Tentative Typical Drawing of Signal & Telecom Building for EI work at Itarsi-B station

WCR DRG.NO.BPL/S&T/P/TEI/25-26

Tentative Typical Drawing of Signal & Telecom Building for E.I. work for Surgaon Banjari, Charkheda Khurd & Barud station for high level platform

Tentative Typical Drawing of Signal & Telecom
Building for E.I. work for CHHANERA &
DAGARKHEDI station

BUILDING FLOOR PLAN

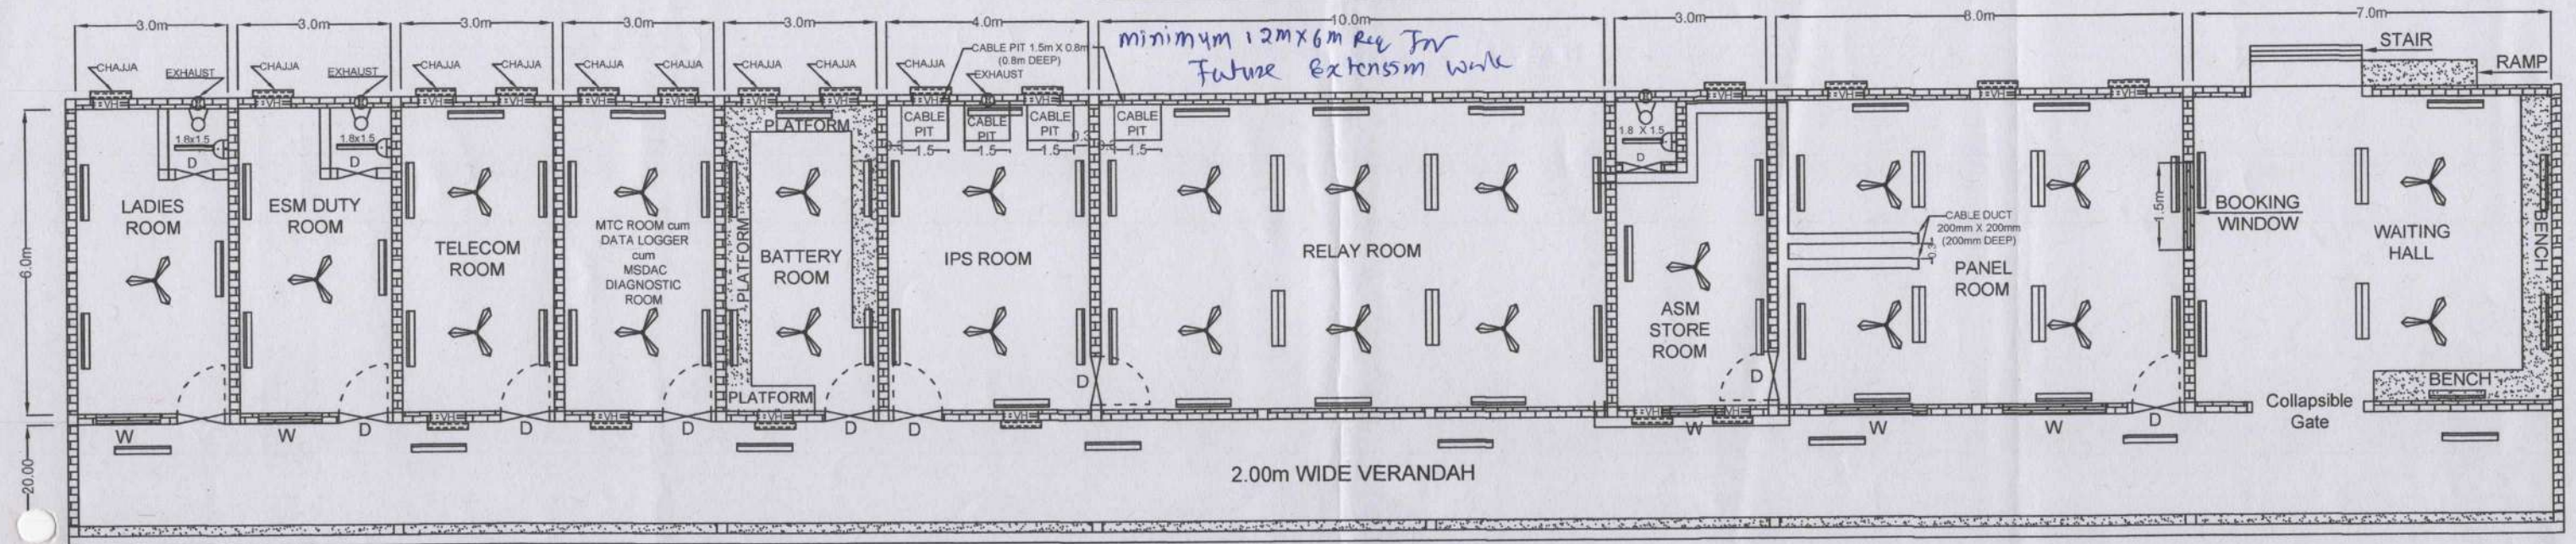
- 18) PLINTH LEVEL OF BLDG. 1200MM FROM RAIL LEVEL.
- 19) SUFFICIENT AC TO BE PROVIDED AS PER COOLING REQUIREMENT IN RELAY ROOM. to maintain 28°C uniform Temp during summer season with spend by arrangement.

All Electrical works to be done as per Technical Specification and scope of work to be finalized by Electrical (A). Window Ac with protective cage to be provided.

* Separate Electrical Panel cum Duty Room must be Required

WCR DRG.NO.BPL/S&T/P/7E/25-26

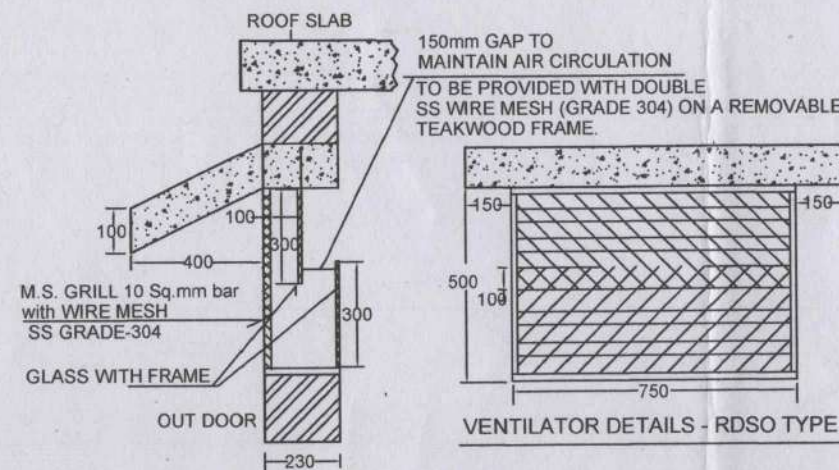
* Separate Electrical panel room required.

All Electrical works to be done as per Technical Specification and scope of work to be finalized by Electrical (A). Windows AC with protective cage to be provided.

to maintain 25°C uniform temp. during summer season. with stand by arrangement.

Minimum 12m x 6m Req. For Future
Extension wk.

WCR DRG.NO.BPL/S&T/P/7EI/25-26

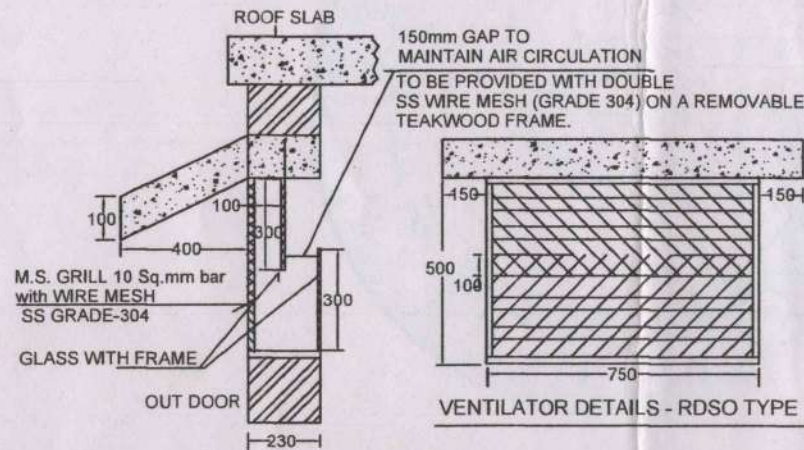
- 18) PLINTH LEVEL OF BLDG. 1200MM FROM RAIL LEVEL.
- 19) SUFFICIENT AC TO BE PROVIDED AS PER COOLING REQUIREMENT IN RELAY ROOM. *# to maintain 28°C uniform temp during summer*

* Separate electrical panel room required.

Minimum 12.0m Ref. for Future Extension Work.

* Seperate Electrical Panel/room required.
